# NOTICE OF DECISION

### CLASS 3 SITE PLAN REVIEW / URBAN GROWTH AREA PRELIMINARY DECLARATION / CLASS 2 ADJUSTMENT CASE NO.: SPR-UGA-ADJ20-06

**SUMMARY:** A proposal to construct a 22,600 square-foot building at an existing food processing facility, with associated site improvements.

**LOCATION:** 1965 Claxter Rd NE

1 SITE PLAN  
1" = 20'-0"

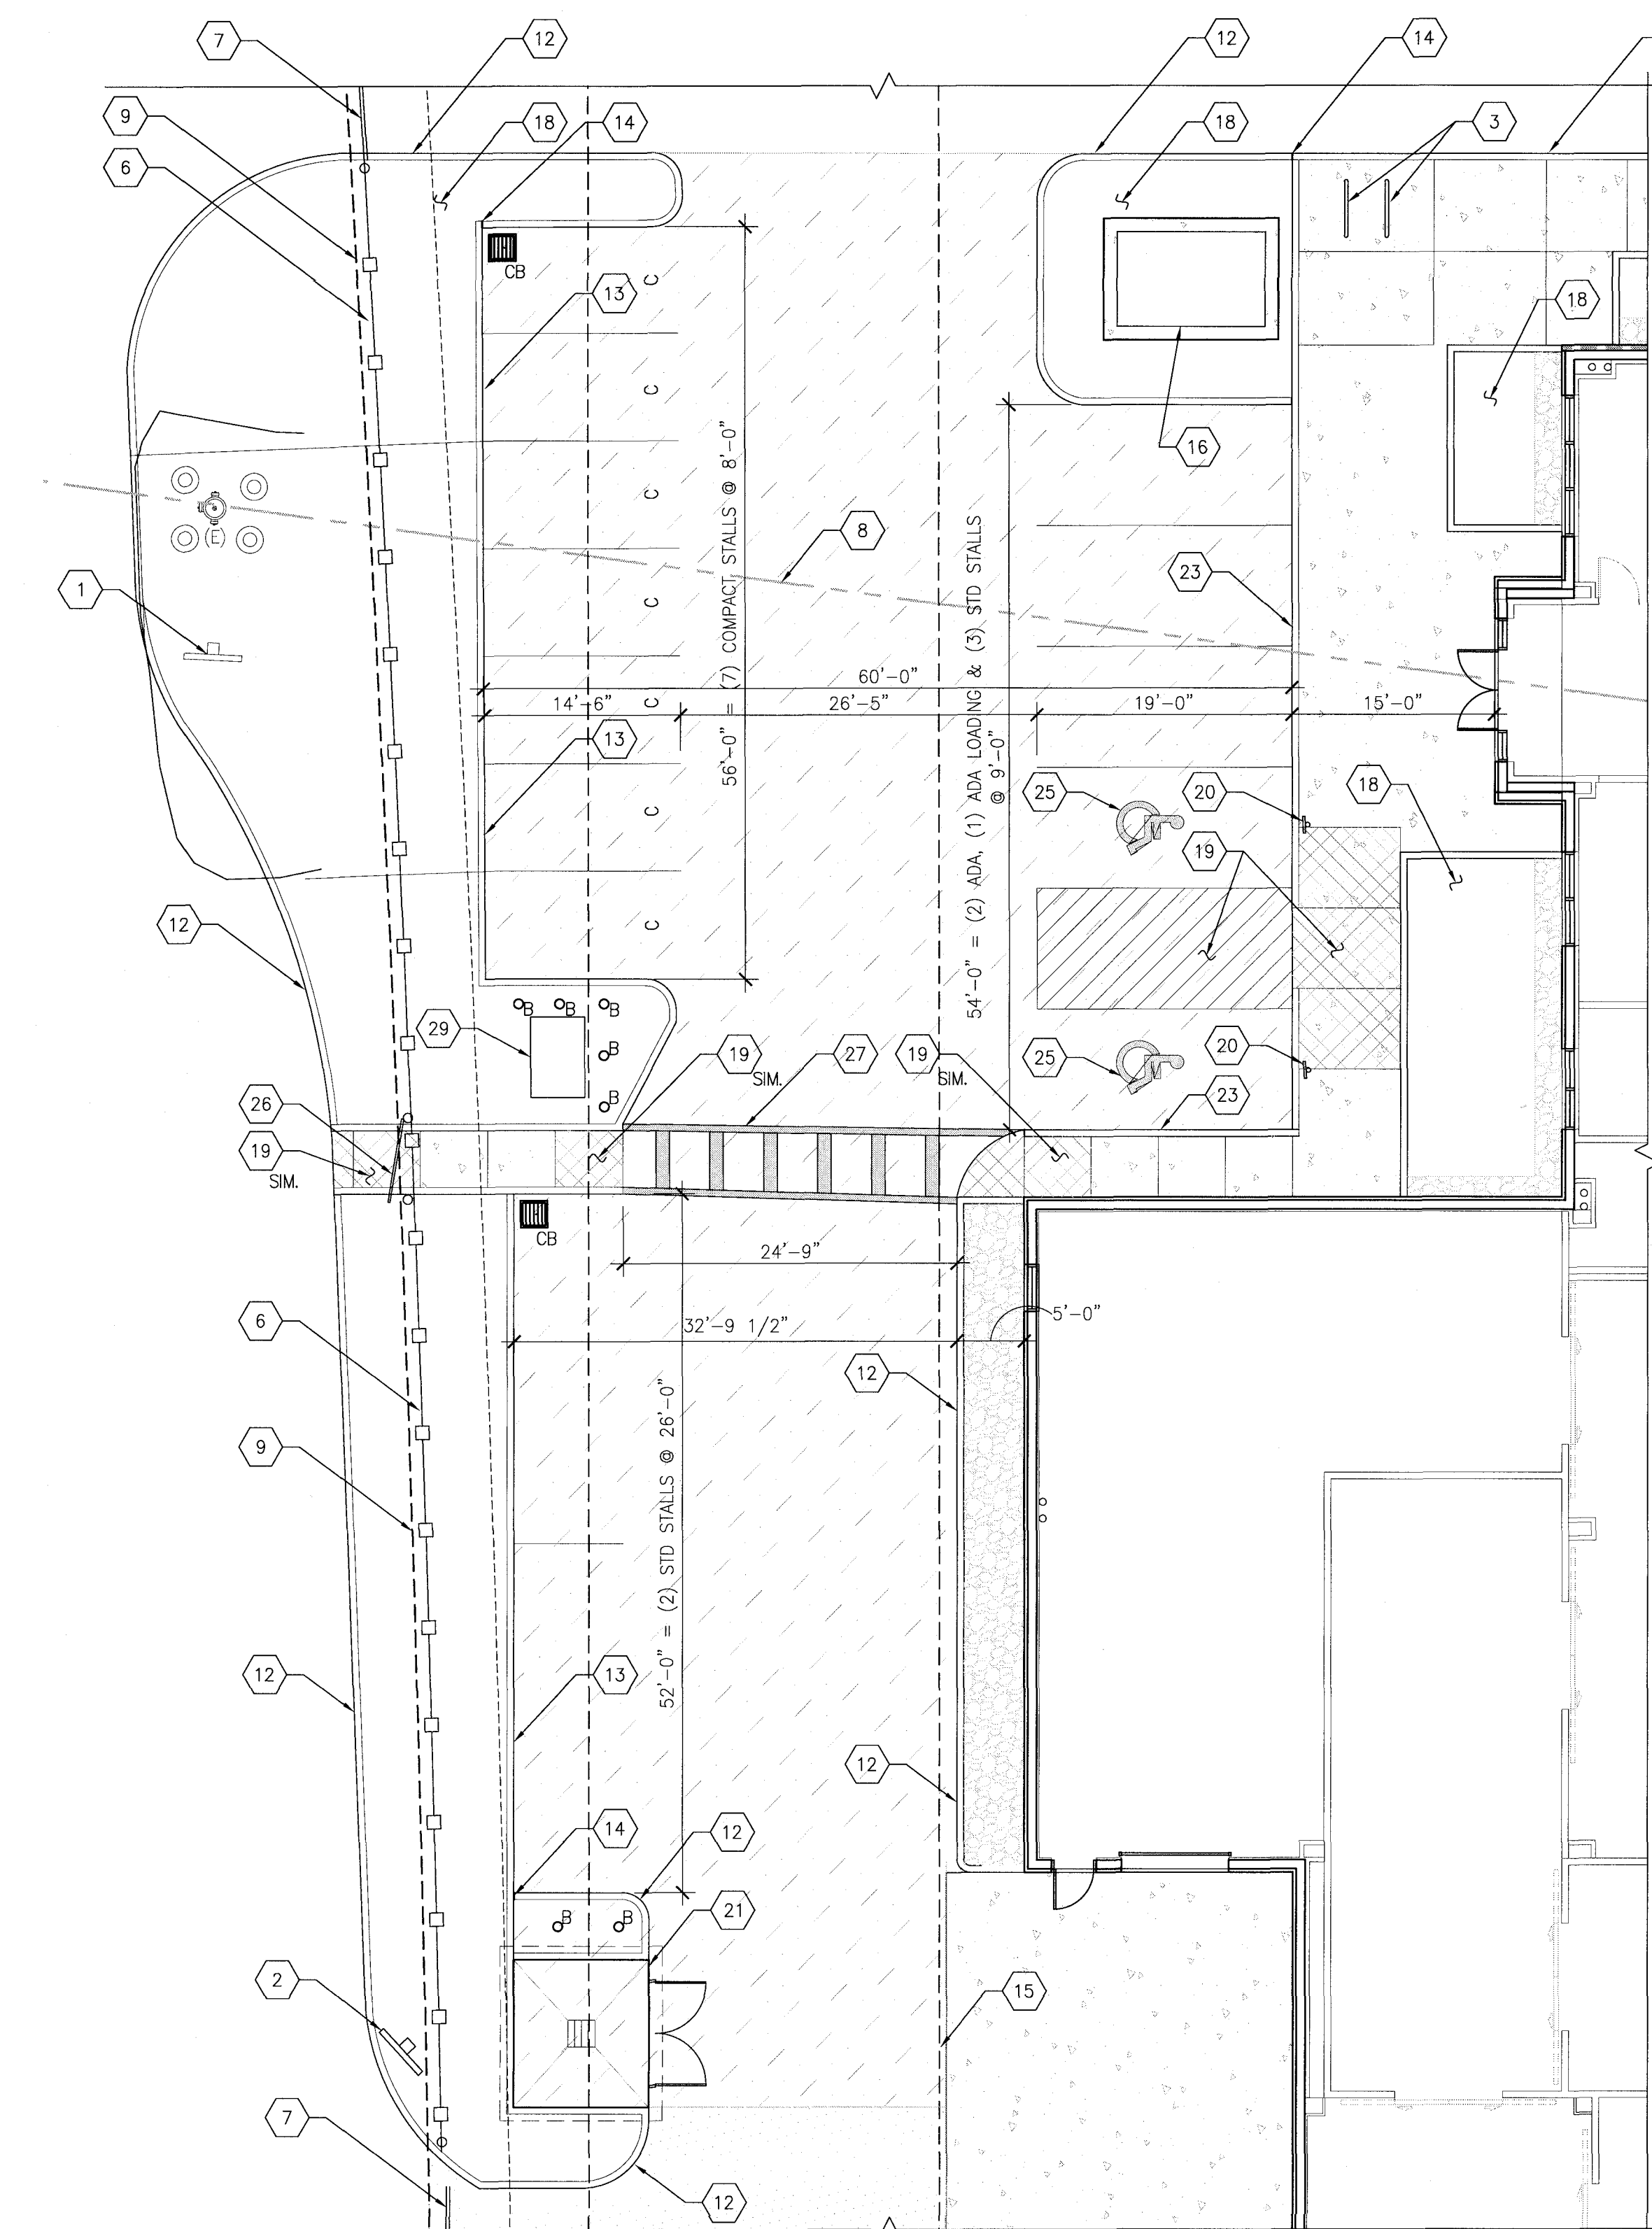
**Finding:** The proposed plans show a single pedestrian connection between the flag-lot accessway and the main entrance of the proposed 22,600 square-foot building (Building B), which is proposed to be connected to the existing 3,821 square-foot building (Building A) with an internal pedestrian connection. No pedestrian connection is required to the Salem Parkway, and there are no existing or planned transit stops along an adjacent street.

**Finding:** As proposed, the development would include a pedestrian connection between the two buildings which uses ADA-detectable warning surfaces as it passes through parking lot drive aisles and loading area. The City's traffic engineers reviewed the proposal and indicated that ADA-detectable warning surfaces are not intended to be used as walkways. They recommended that the plan be revised to use a different material for this portion of the pedestrian connection.

**Finding:** The proposed off-street parking area is developed consistent with the additional development standards for grade, surfacing, and drainage. Bumper guards and wheel barriers are not shown for parking spaces on the proposed site plan, as required by SRC 806.035(i). To ensure the proposed development complies with the additional off-street parking development standards of SRC 806.035(f)-(m), the following condition of approval shall apply:

**Finding:** As shown on the site plan, the proposed development includes 4 new bicycle parking spaces. The proposal meets the standard.

**Finding:** A minimum of 1 off-street loading space is required for the proposed development. As shown on the proposed site plan, 2 off-street loading spaces are proposed—one adjacent to each building. The proposal meets the standard.

**Condition 2:** All portions of the pedestrian connections shown on the site plan which cross driveways, parking areas, drive aisles, and loading areas, shall be paved with a different paving material.

**Condition 3:** Provide bumper guards or wheel barriers so that no portion of a parked vehicle will overhang or project into required setbacks and landscape areas, or into pedestrian accessways.

PLANTING PLAN  
SCALE 1"=20'-0"

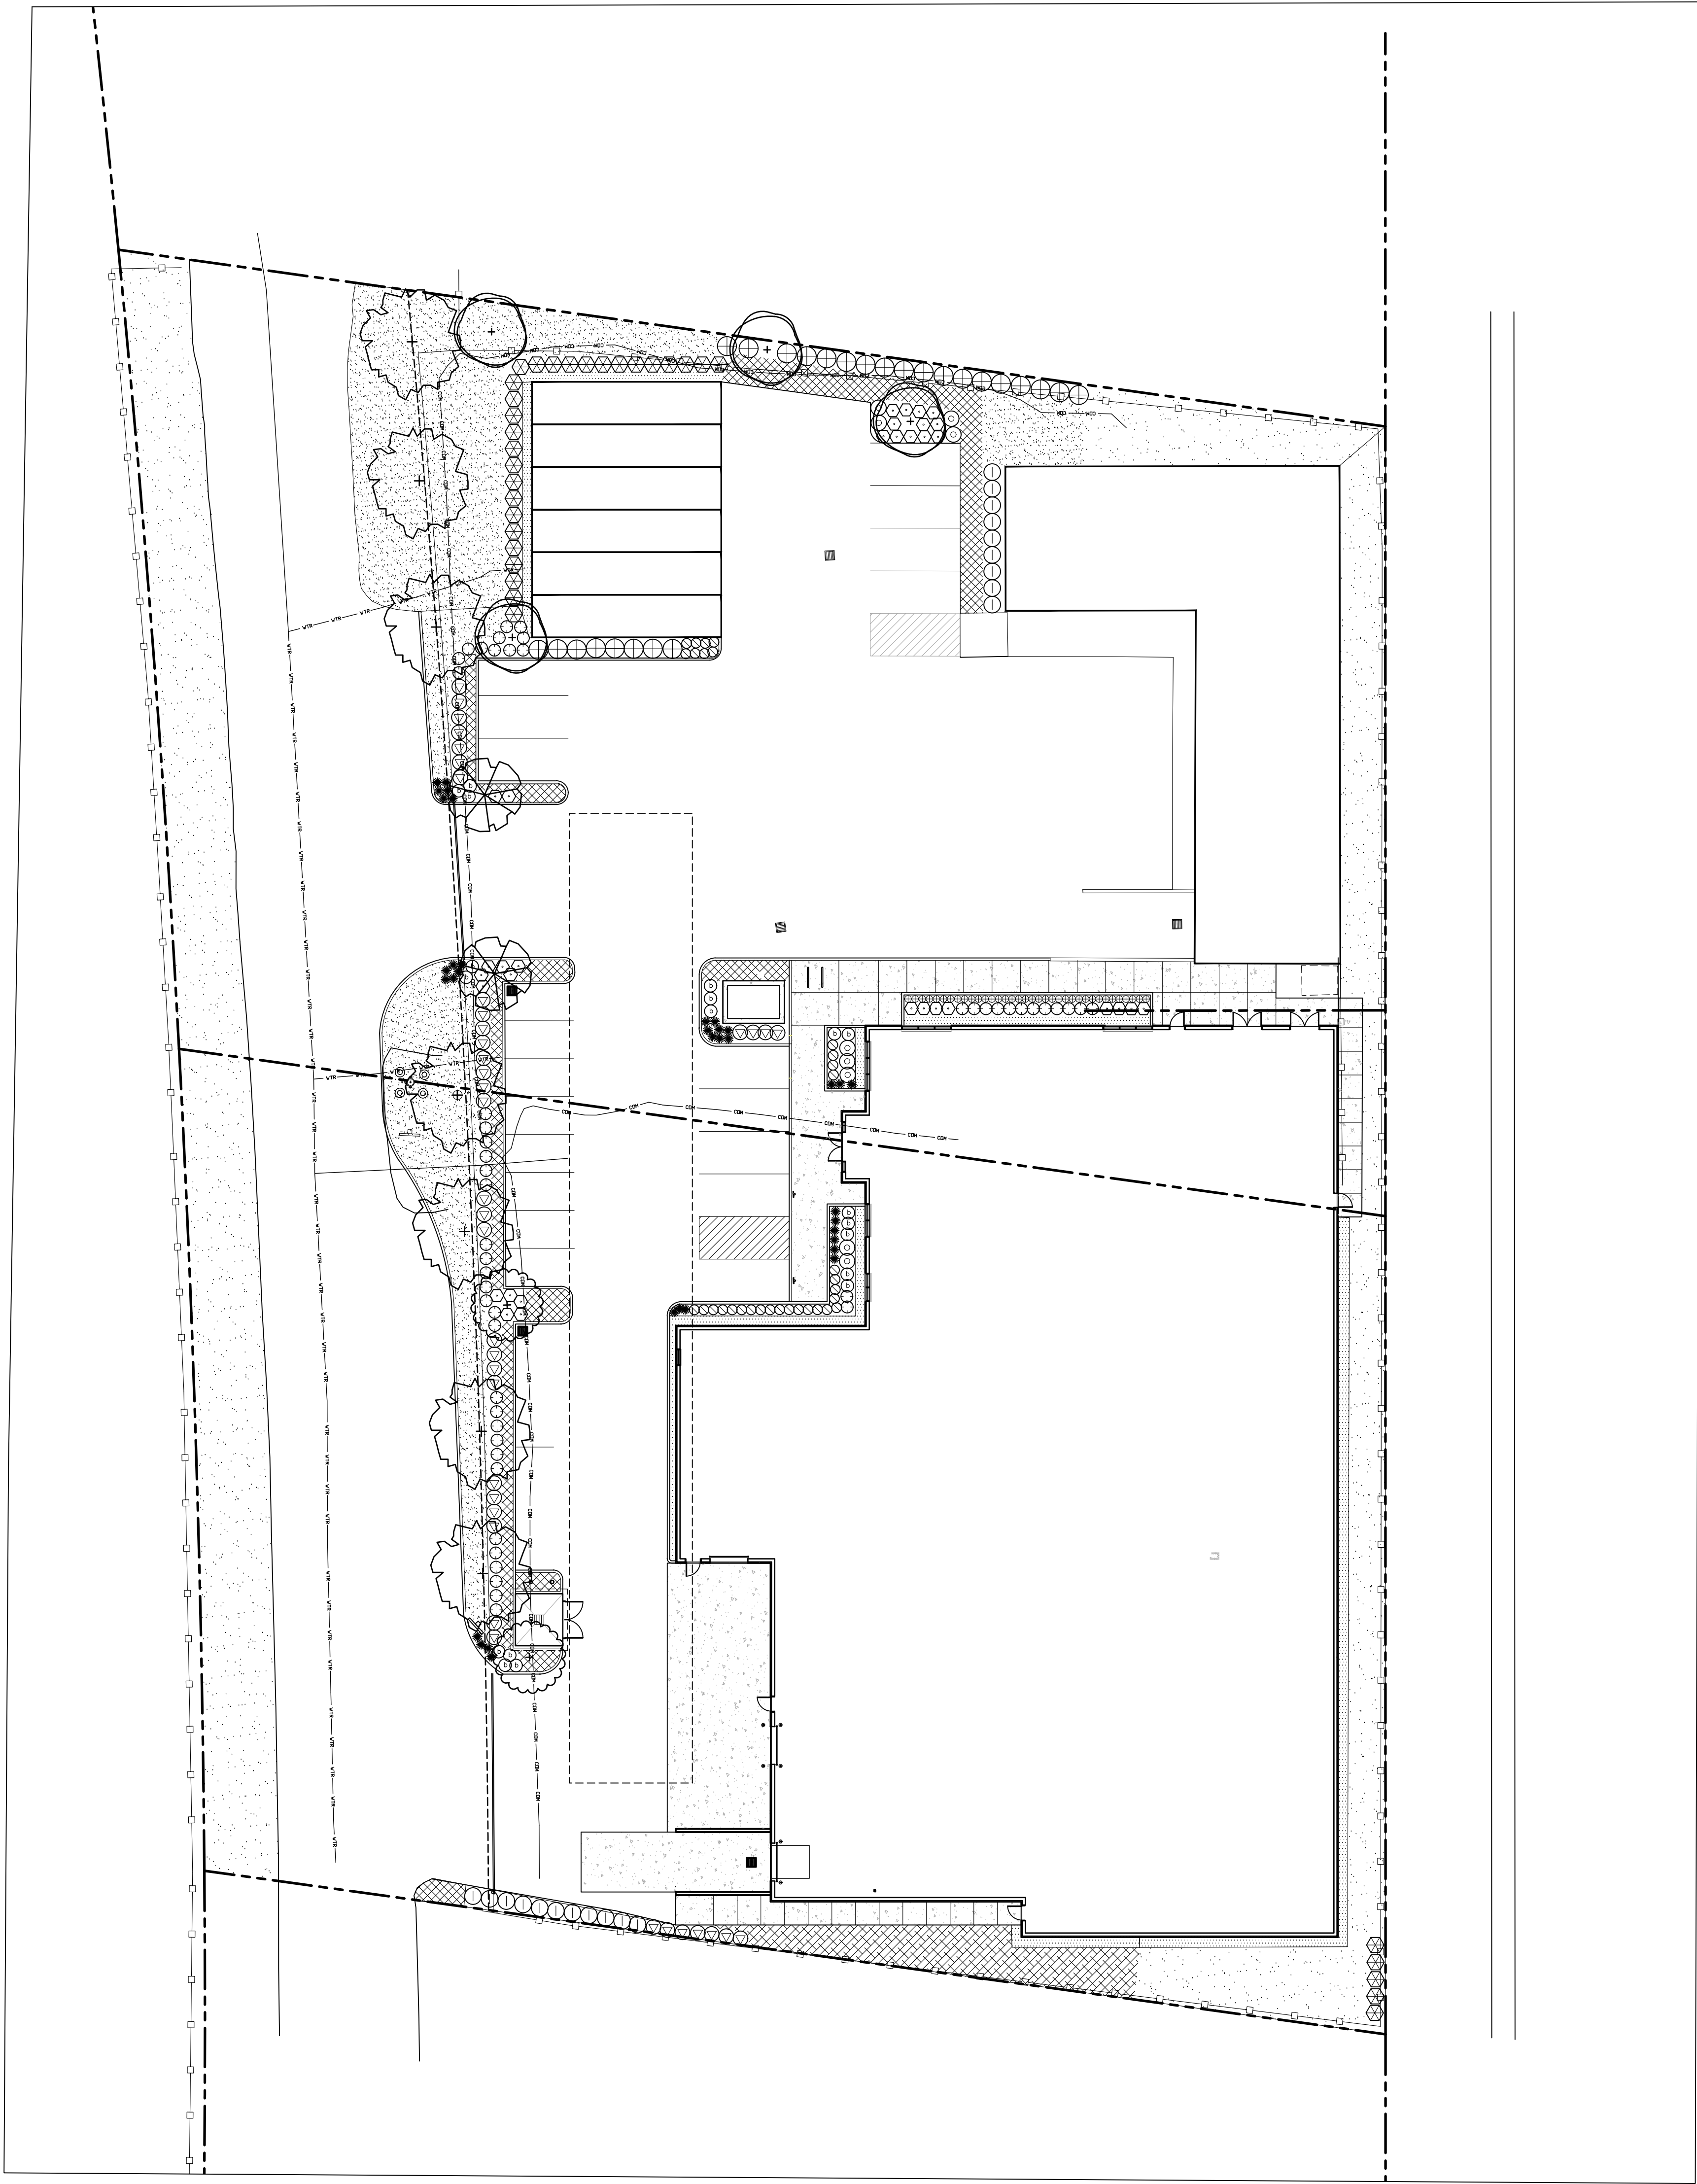
**Finding:** The applicant has submitted a preliminary landscaping plan, which shows the required setback areas landscaped to the Type A standard. With a total development site area of approximately 87,120 square feet, the site requires a minimum of 13,068 square feet of landscaped area, or 15 percent of the development site. The preliminary landscaping plan shows approximately 19,256 square feet of landscaped area across the development site, or 22.1 percent of the development site.

Additionally, the applicant has proposed landscaping areas within portions of the flag lot accessway which abut the boundary between the accessway and the remainder of the development site. This landscaping will add additional buffer space between the limited traffic which travels on the flag lot accessway and the activity occurring on the development site, and those on nearby properties. To ensure that the proposed development meets the requirements of 250.005(d)(2)(A), the following condition of approval shall apply:

**Condition 8:** A minimum of 120 plant units shall be planted within the flag lot accessway within the development site. These plant units shall be located between the paved portion of the accessway and the easternmost boundary of the accessway.
